10/021,602

Office Action Summary

DETAILED ACTION

Fig. 1a

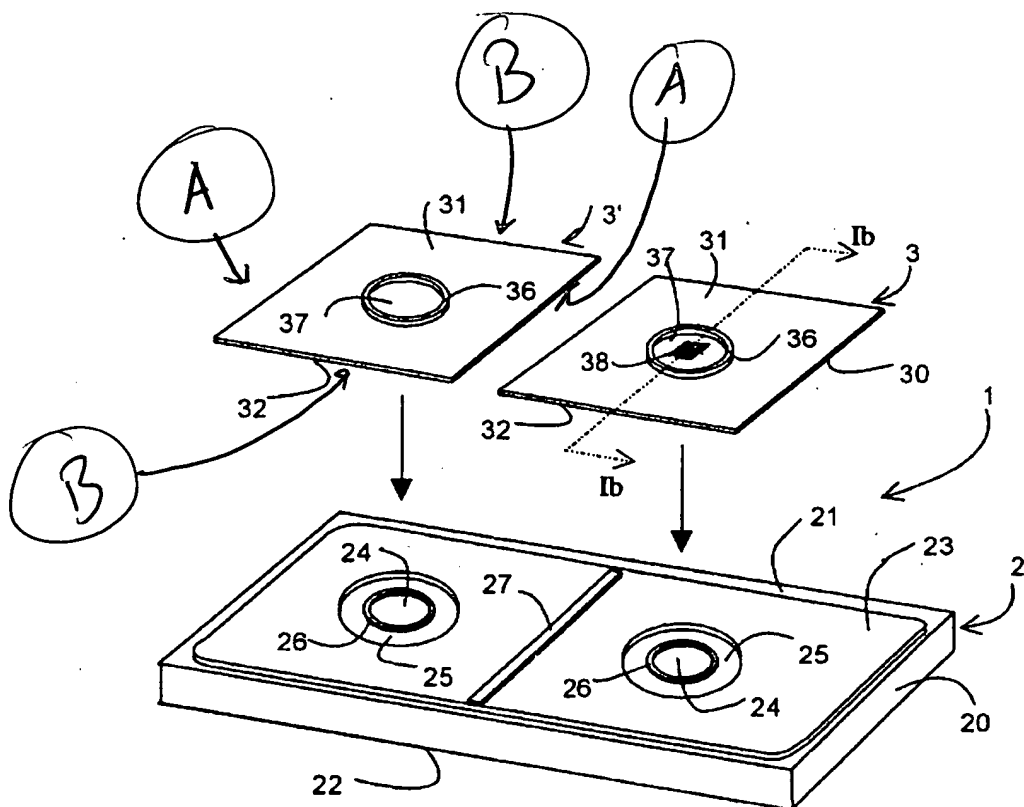
feature. The Examiner has provided an annotated version of Figures 1A and 1B. As shown in Figure 1A, Tolles teaches a substrate (20), having a spacer element (23) and a cover slip (3 & 3'). The spacer element is comprised of a film of given height (column 3, lines 29-31) that extends along the substrate (20). The cover slip has two pairs of substantially parallel, opposed longitudinal edges bounding the bottom surface. The Examiner has labeled one of the edges from each of these pairs "A" and "B" in the annotated Figures. The Examiner then notes that when placed together as shown in Figure 1B, the spacer (23) contacts the bottom surface along the edge of the cover slip (3). In addition, the Examiner considers each portion of the spacer (23) that contacts the bottom surface of the cover slip (3) to be a "spacer segment". Given this interpretation, the spacer segments shown in the cross-sectional cut Figure 1B, extend completely along each pair of edges – again, labeled "A" and "B" - of the cover slip as required by the claim. Tolles also shows additional spacer elements spaced in from the edge of the cover slip (instant claim 56) in Figure 1B.
